TAS5508A Errata

Figure 1. I²C Pullup Circuit (With No Series Resistor)

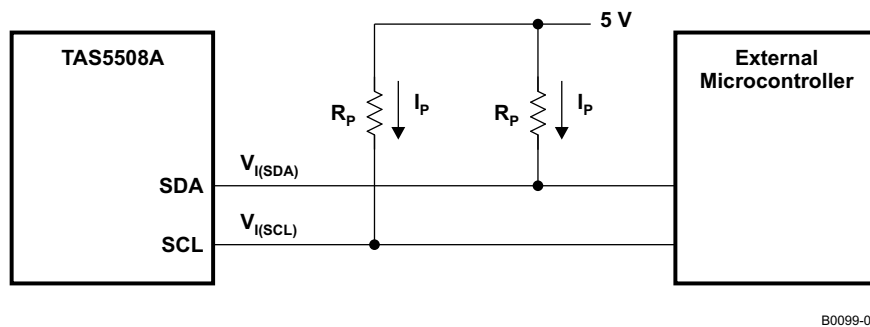
In systems using 5-V CMOS buffers for the I²C interface, special pullup resistors are required.

The I²C specification requires that V_{IH} is $0.7 \times V_{DD} = 3.5$ V when V_{DD} is 5 V. In some 5-V CMOS systems, the normal value for the I²C pullup resistor is 4.7 k Ω . This could cause the voltage not to rise above 3.47 V, which violates the specification. The root cause has been identified as a TAS5508B 5-V-tolerant buffer issue.

It is recommended that the I²C pullup resistors R_P be 3.3 k Ω (see Figure 1). If there is a series resistor in the circuit (see Figure 2), then the series resistor R_S should be less than or equal to 300 Ω .

M0012-01

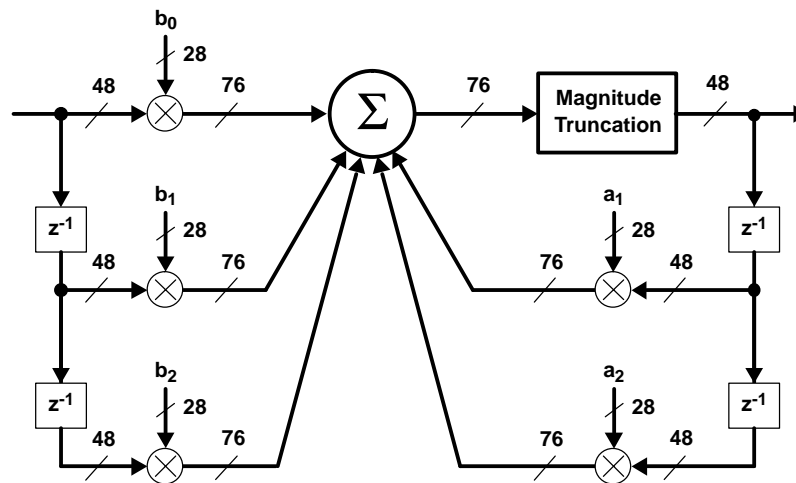
The TAS5508A exhibits a one-sample delay on channels 3, 4, 7, and 8 for sample rates of 32, 44.1, and 48 kHz. The delay occurs in the PWM section.

This time misalignment can impact applications where the TAS5508A is used to provide crossover filtering and bi-amplification, as in powered loudspeakers. The problem that occurs in these cases is that a one-sample time delay between either the high-pass or low-pass path causes an error in the overall crossover frequency response.

The time misalignment can be corrected by using a biquad to provide a one-sample delay for each of the nondelayed PWM channels for the 48-, 44.1-, and 32-kHz sample rates.

When the 8×2 crossbar mixer provides a 1:1 input-to-output connection, an eight-channel loudspeaker configuration uses one of the seven biquads in channels 1, 2, 5, and 6 to provide a one-sample delay.

To produce a one-sample delay with one of the TAS5508A biquads:

1. Set the b_1 biquad coefficients to a gain of 1.
2. Set all of the other biquad coefficients (b_0 , b_2 , a_1 , and a_2) to a gain of 0, as shown in the following diagram and table.
